Subject: Roofing detail recommendations

SYSTEM
**TPO SINGLE PLY RETROFIT
 OVER STANDING SEAM
 METAL ROOF
 (RHINOPLATE)**

RHINOPLATE FASTENED TPO MEMBRANE TO PURLINS			
DRAWING NO. T-RSPR-1	SCALE N.T.S	ISSUE DATE 4-6-2010	REV. NO. 2
CAD FILE: T-THERMOPLASTIC_RHINOPLATE_LAYOUT_10.dwg			Johns Manville is a Manufacturer of commercial roofing products and offers this general conceptual information to you as a courtesy. This complimentary assistance is not to be used or relied upon by anyone as a substitute for professional engineering design and documentation required by building code, contract, or applicable law. By accepting these comments you agree they do not constitute any representations, endorsements of, or an assumption by Johns Manville of any liability for either the adequacy of the design of this building or any other material not supplied by Johns Manville.

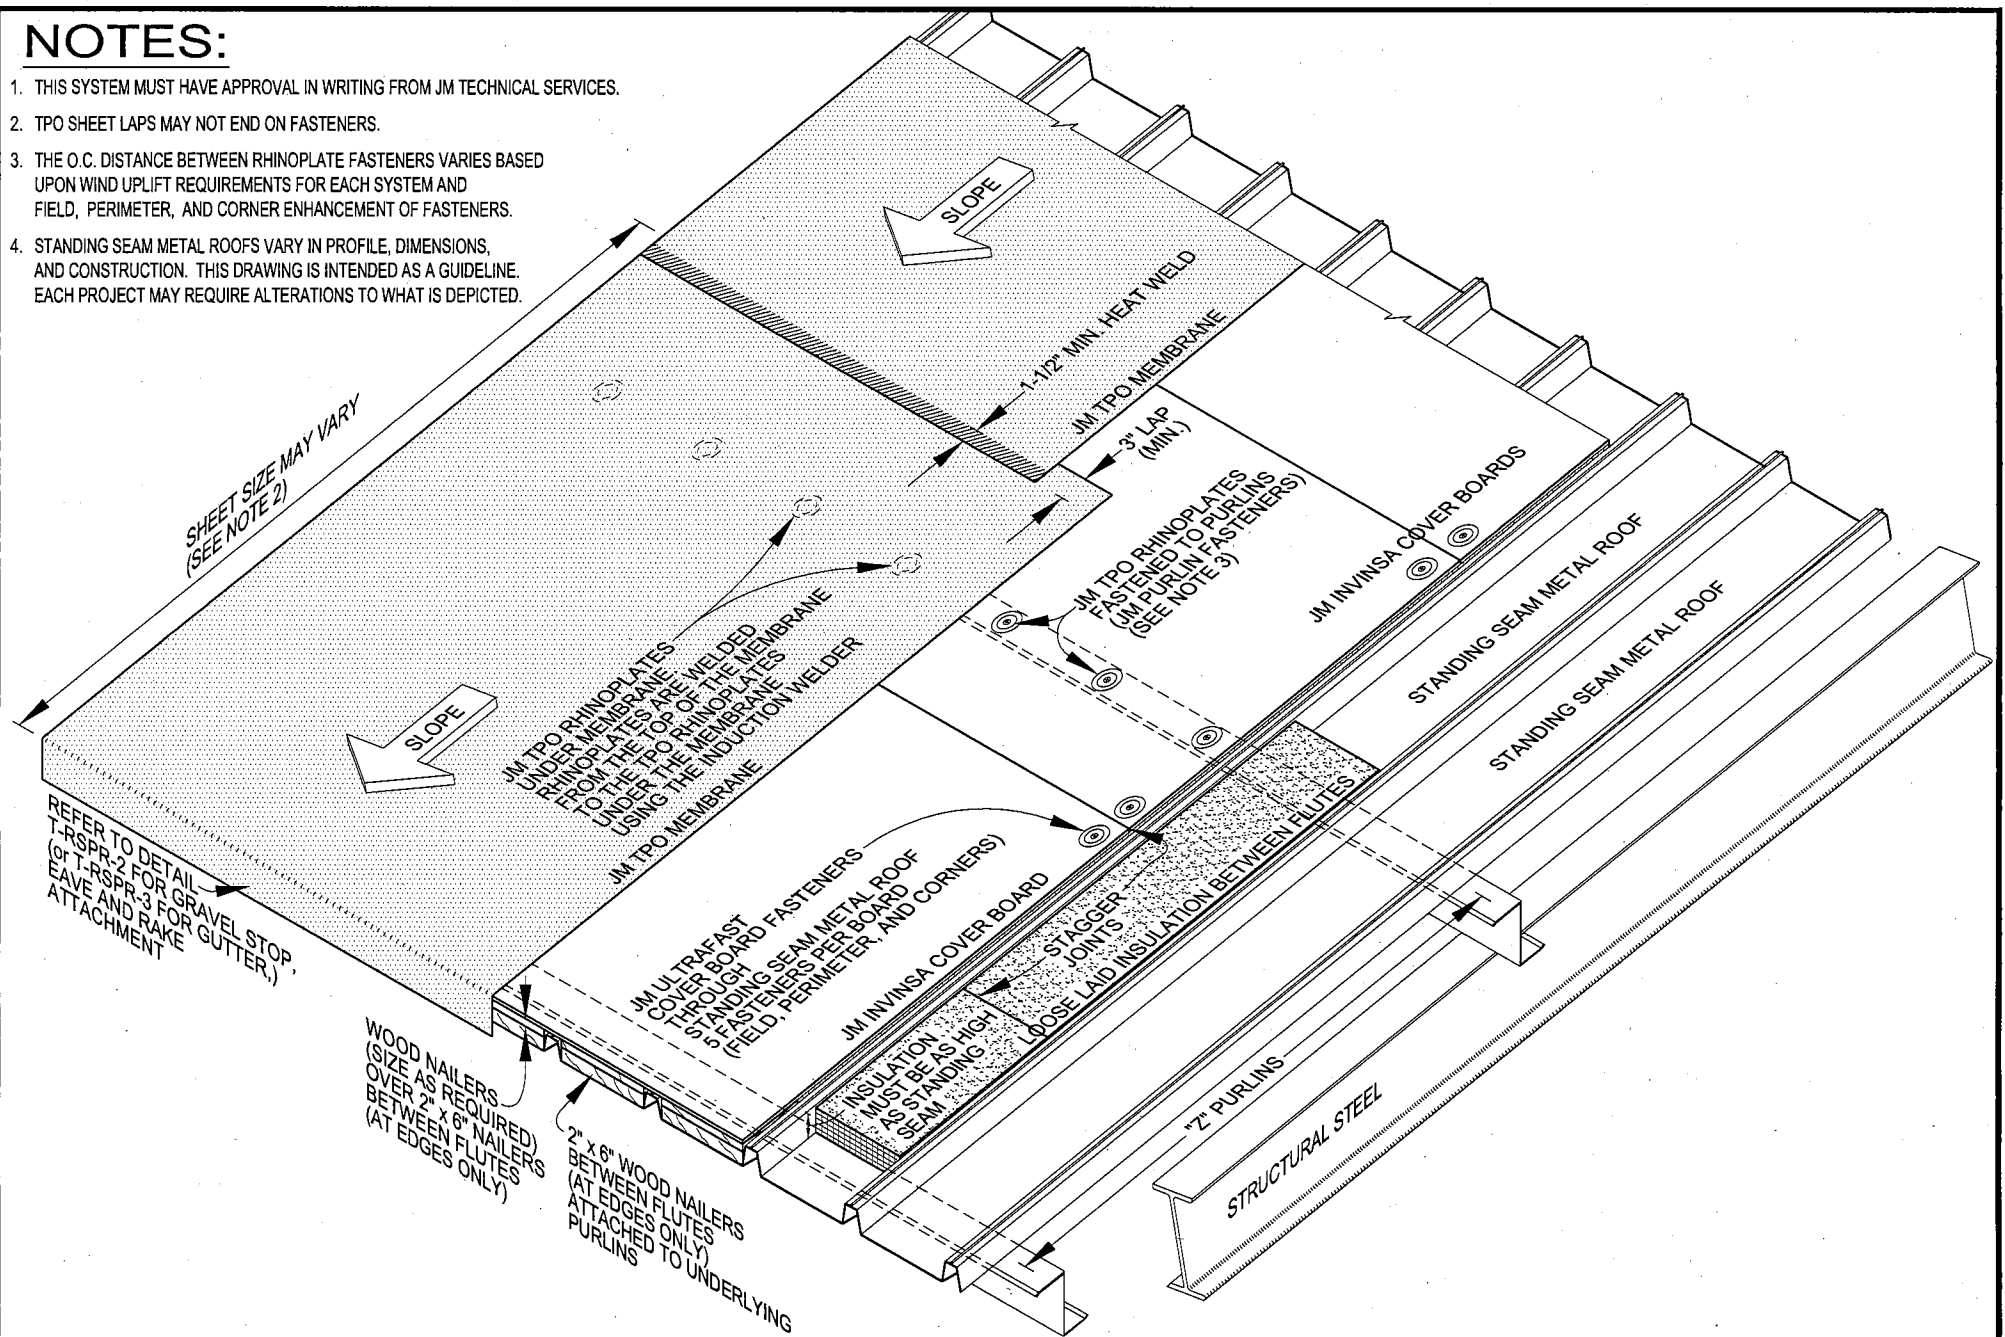
- ? Prior to installing a TPO clad metal insert in the gutter, cut back the roof edge flush with the metal edge support below the roof edge. (That way we are not shrinking the size of the gutter, impeding water flow).
- ? Install wood nailers at all edge details. (See attached detail)
- ? Raise curbs as needed to provide an appropriate base flashing height.
- ? Remove the metal cat walk and replace with TPO walk pad after installing the new roof assembly. Follow the same layout as the cat walk.
